FOURSQUARE AT STERLING RANCH EAST FILING NO. 1 GRADING AND EROSION CONTROL PLAN			
DESIGNED BY	DLG	SCALE	DATE 11-30-22
DRAWN BY	DLG	(H) 1" =	SHEET 2 OF 27
CHECKED BY	(V) 1" =	JOB NO.	1183.23

FOURSQUARE AT STERLING RANCH EAST
FILING NO. 1
GRADING AND EROSION CONTROL PLAN

FOURSQUARE AT STERLING RANCH EAST
FILING NO. 1
STREET IMPROVEMENT PLANS

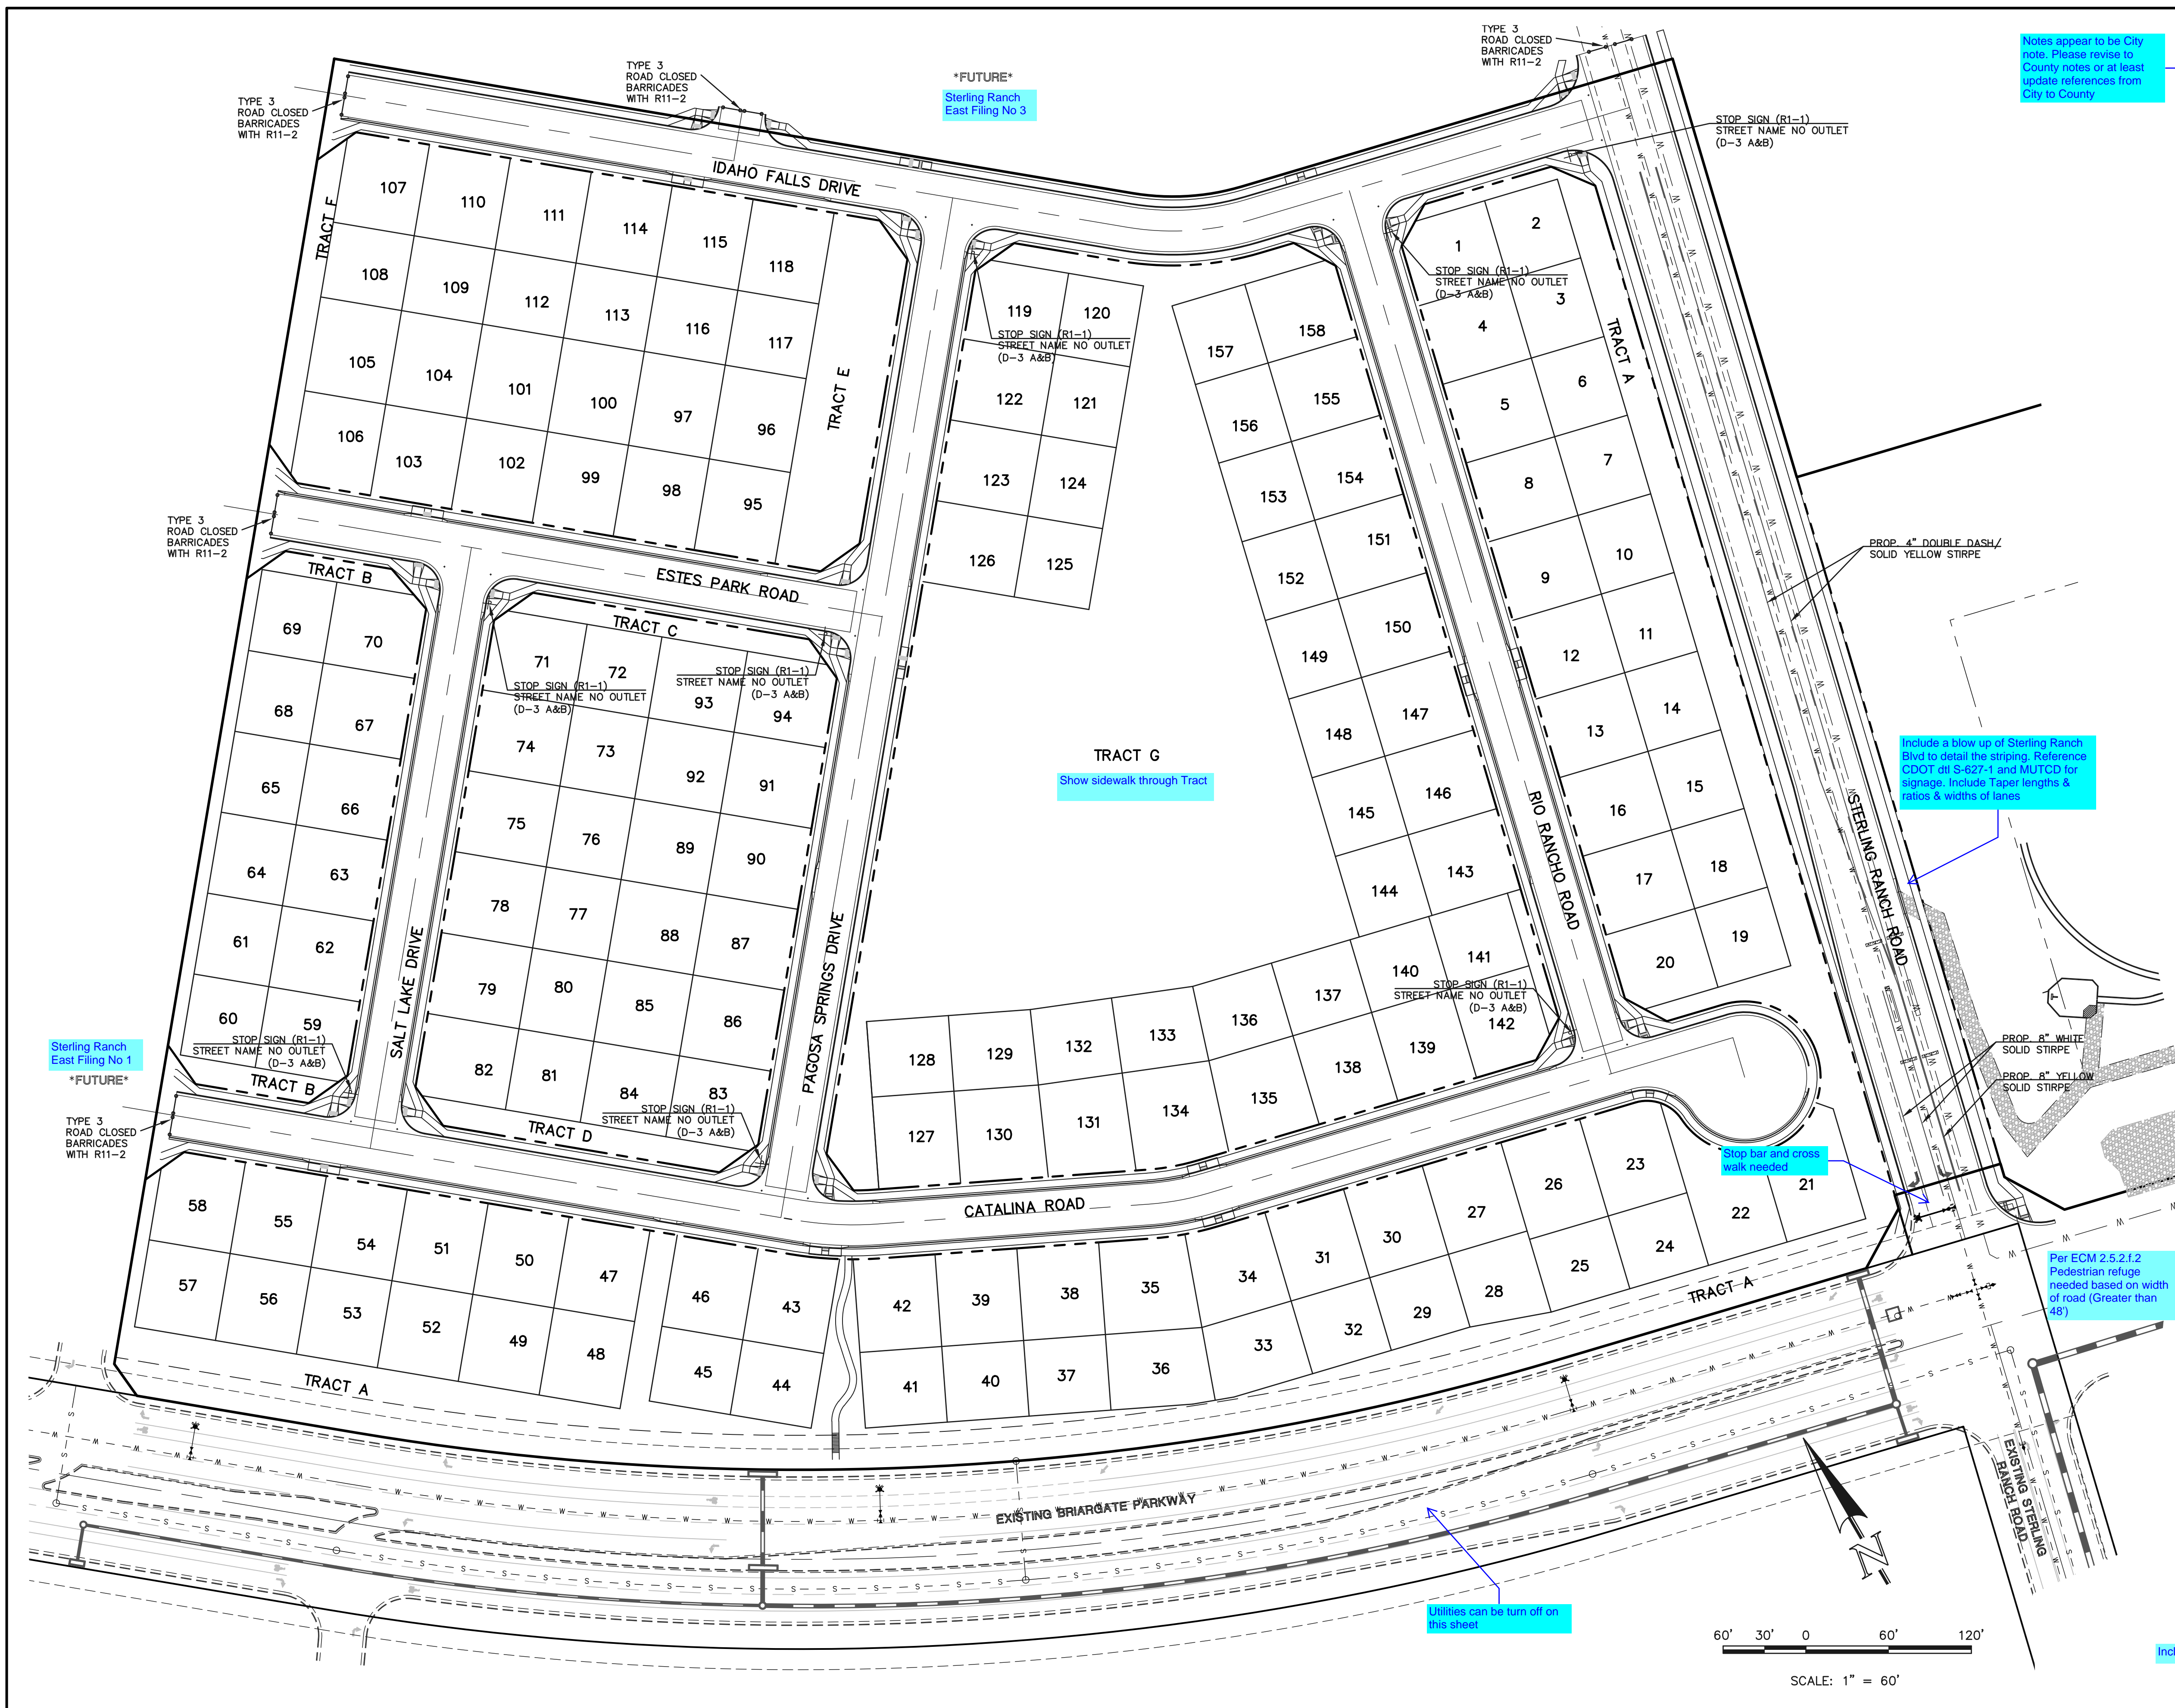
Notes appear to be City note. Please revise to County notes or at least update references from City to County

Include a blow up of Sterling Ranch Blvd to detail the striping. Reference CDOT on S-627-1 and MUTCD for signage. Include Taper lengths & ratios & widths of lanes

Include speed limit sign & show locations on map

Show location of this sign on plan or remove

Utilities can be turn off on this sheet

FOURSQUARE AT STERLING RANCH EAST
 FILE NO. 1
 STREET IMPROVEMENT PLANS
 TYPICAL STREET SECTIONS & DETAILS

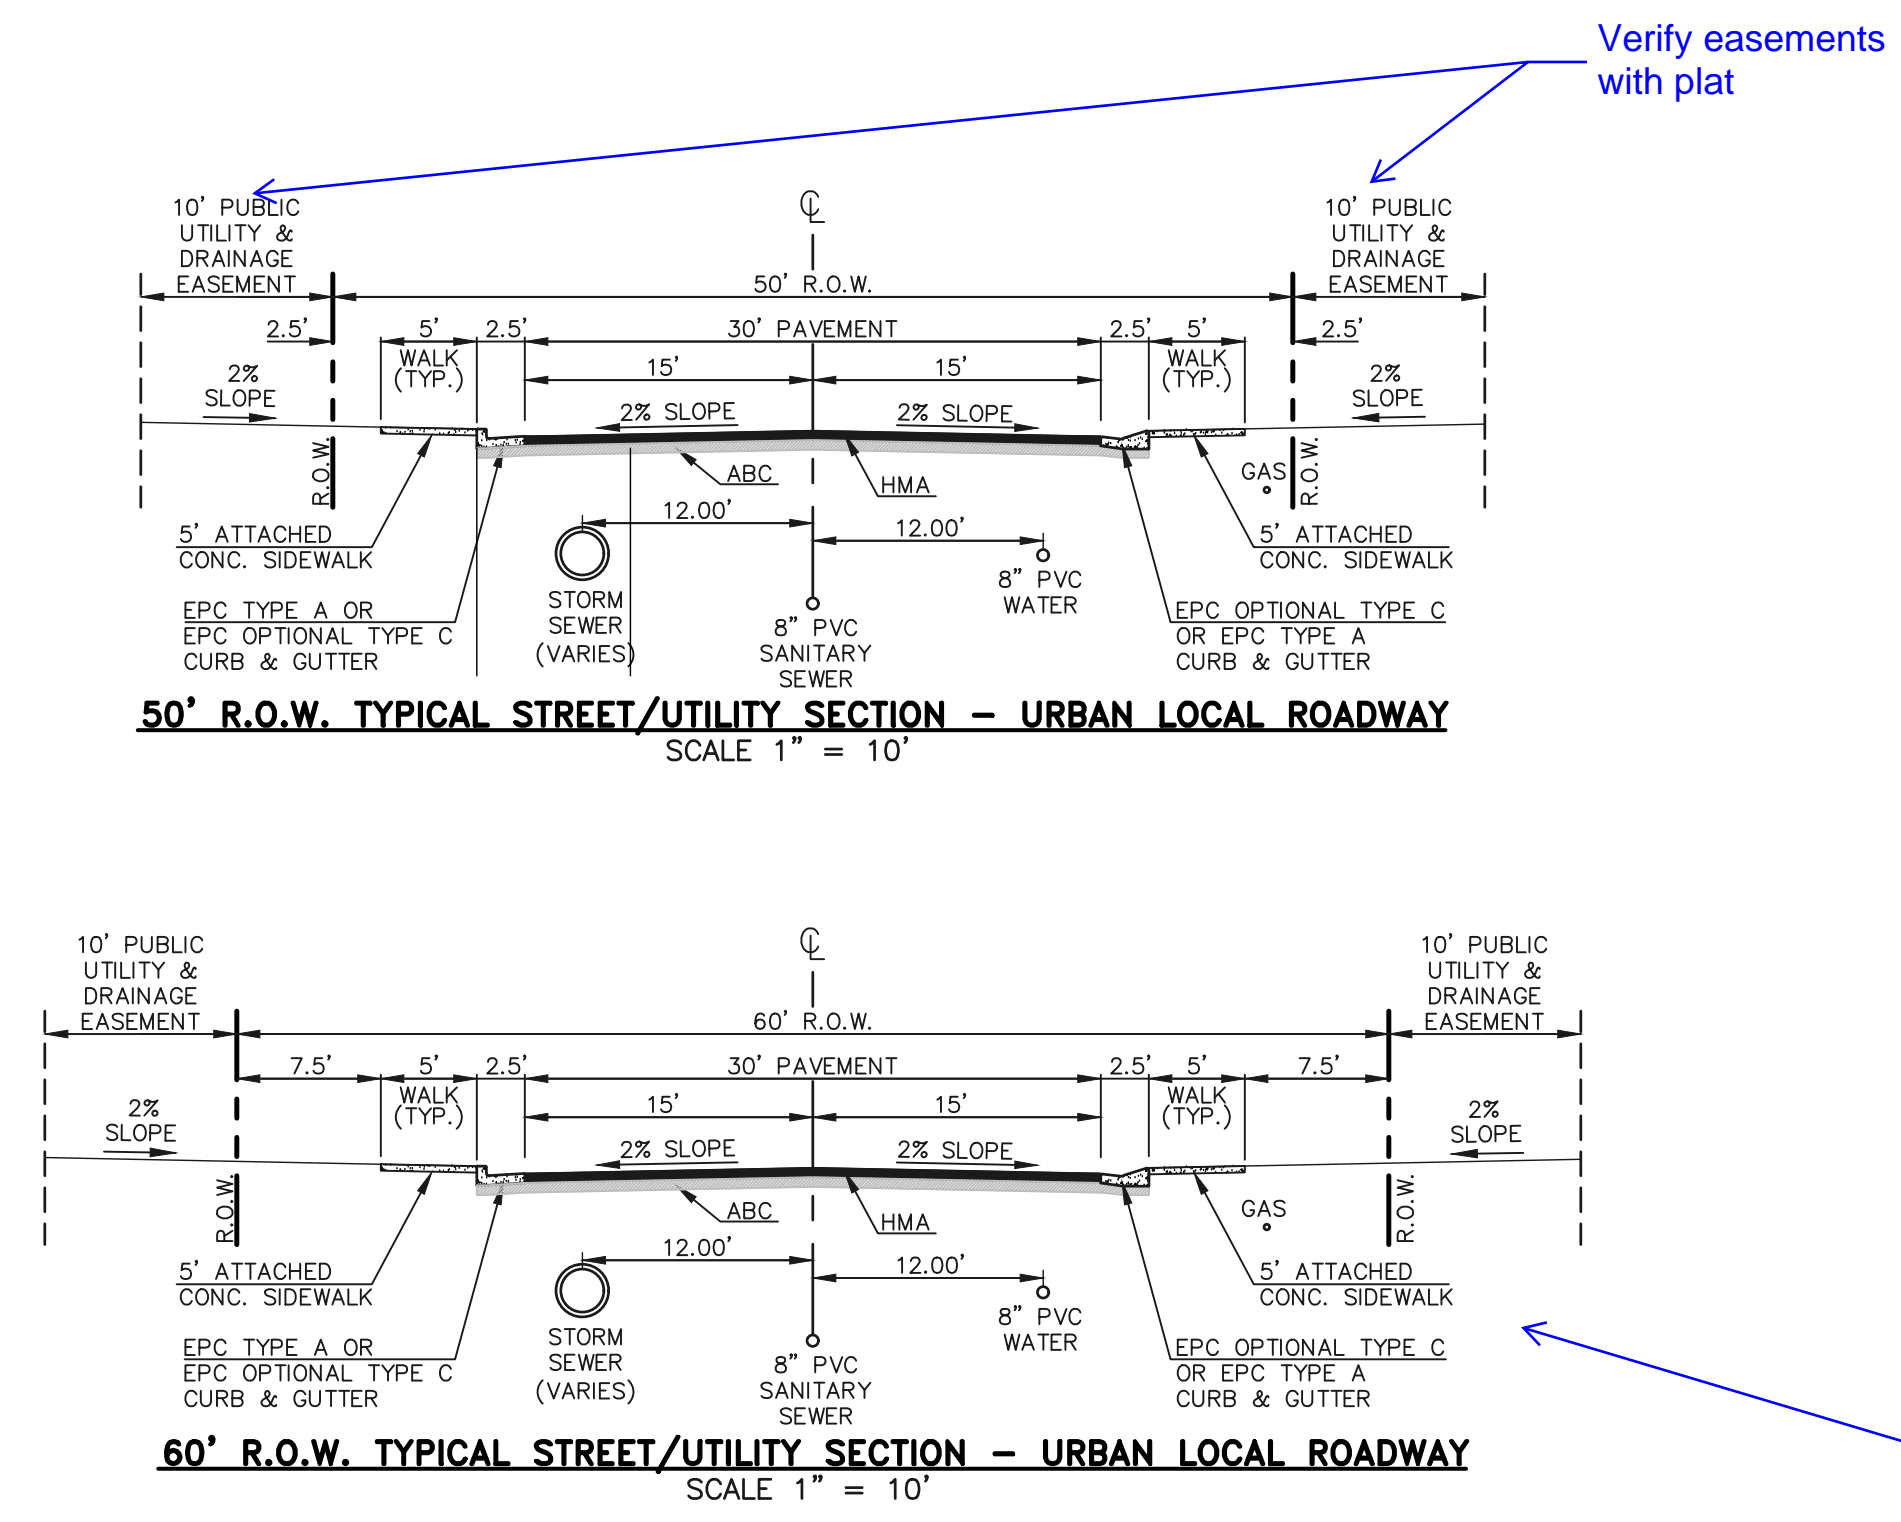
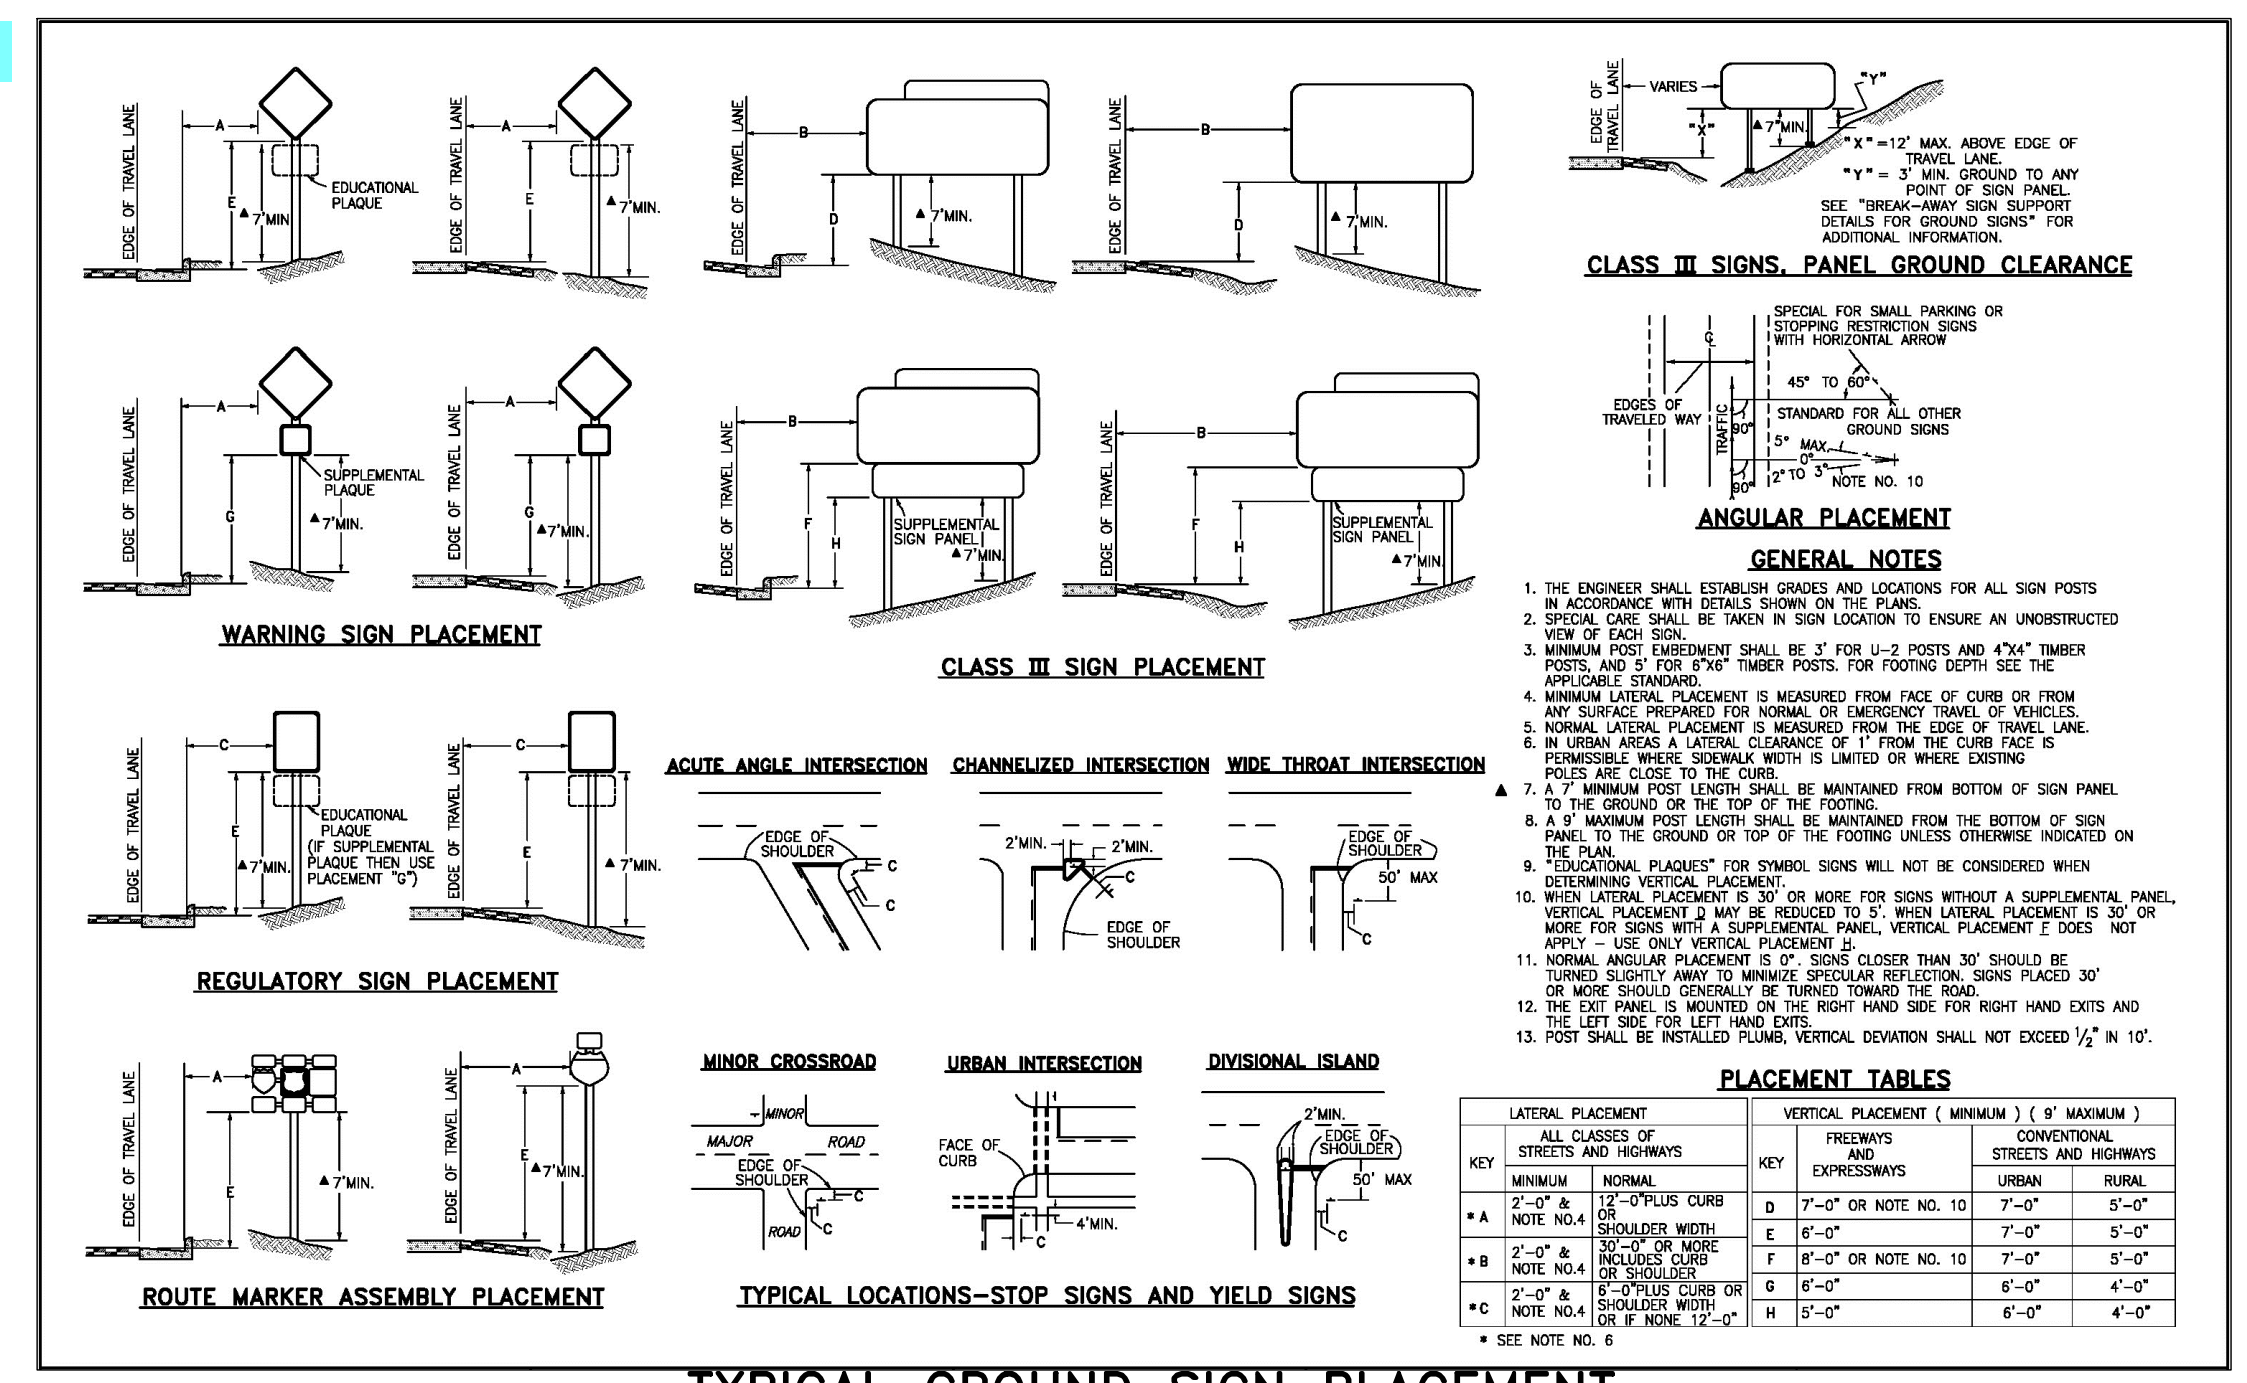
Verify easements with plat

Include details for:
 - Cross pan (ECM DI SD_2-26)
 - Driveway (ECM DI SD_2-24)
 - Screen Wall Detail
 - Retaining Wall Detail
 - Typical Lot Detail as shown on PUD plan

Remove this section as no roads have 60' row

Include section for Sterling Ranch Road (80' ROW)
